## ADDENDUM NO. 3

**Project:** Parking Access & Revenue Control System Equipment Procurement

**Date:** March 22, 2024

# IOWA STREET RAMP - LEVEL 1

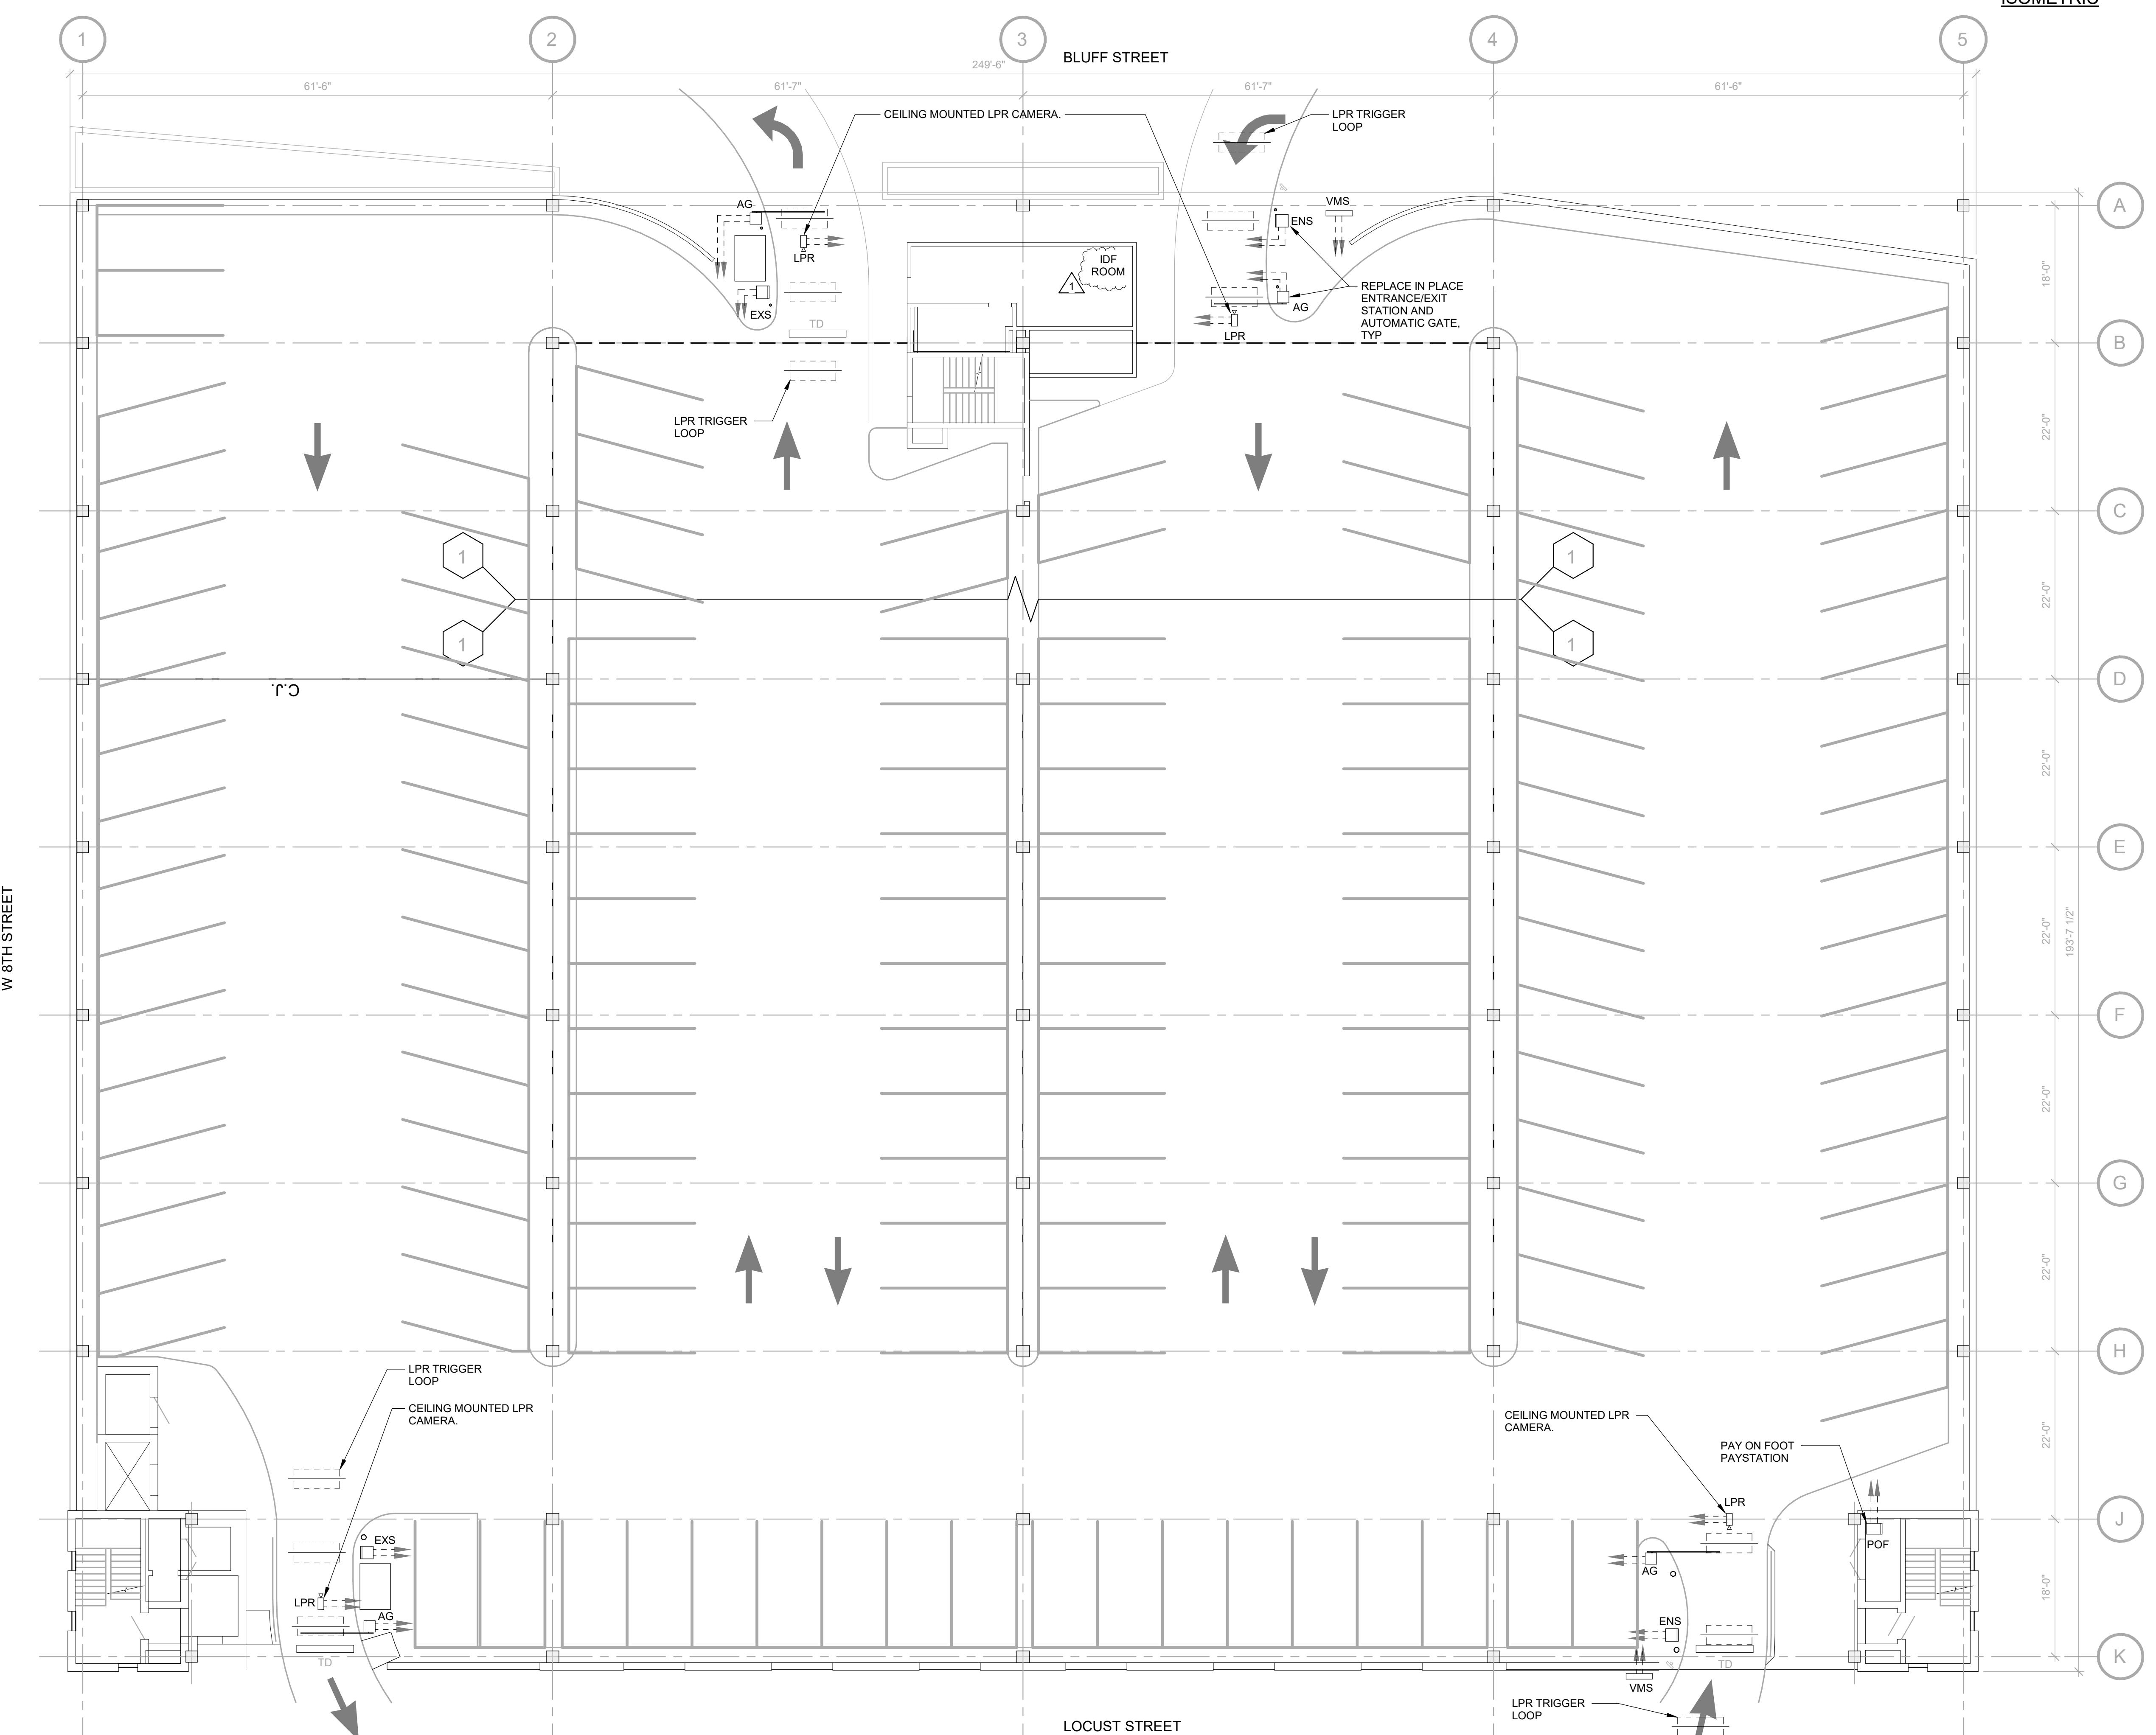
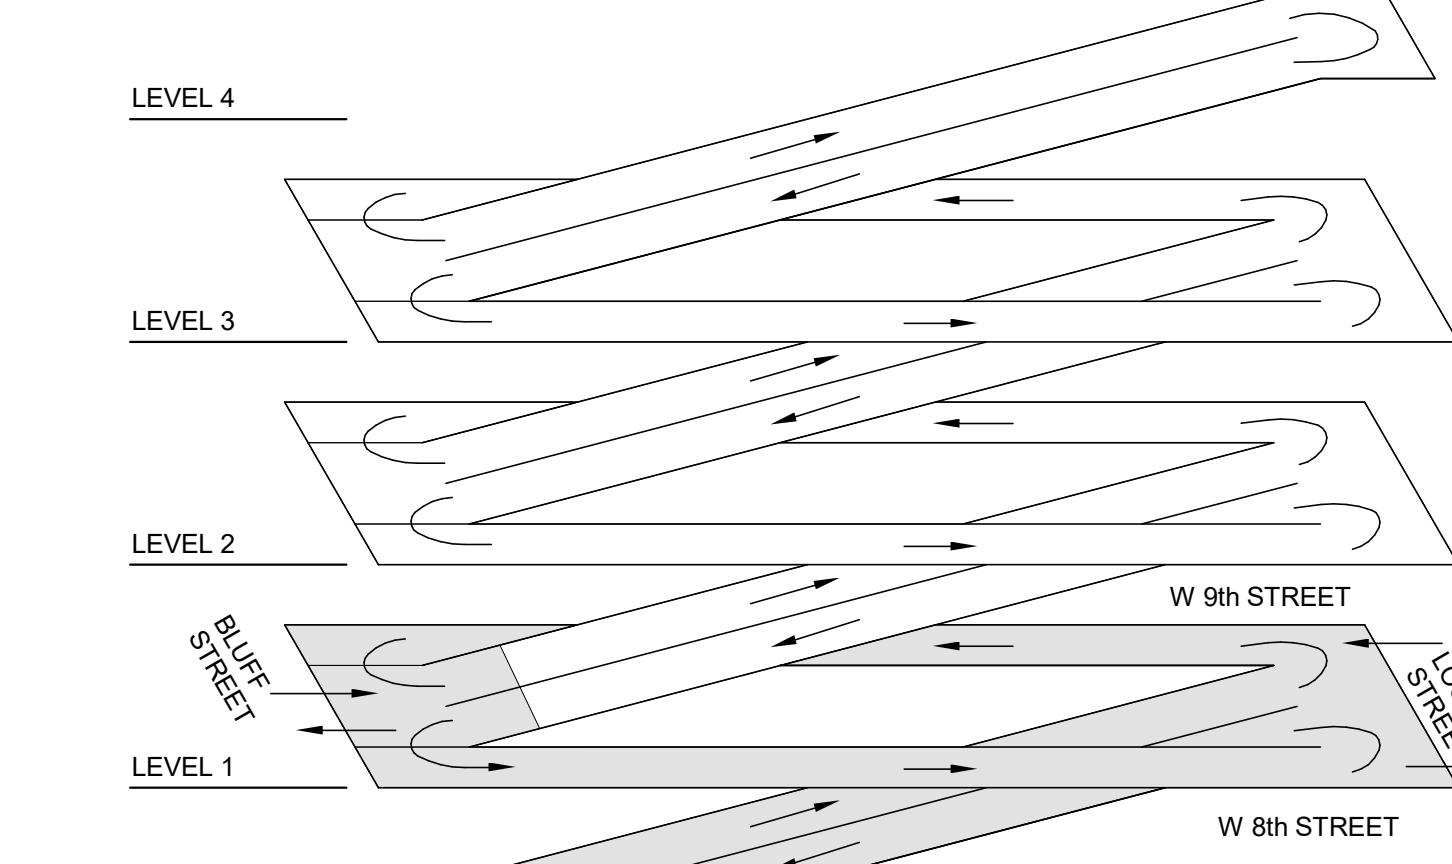
13. Would the City be able to note on each of the drawings the following;
  - o Location of the IDF closets

*Please see the updated construction plans included in the addendum.*
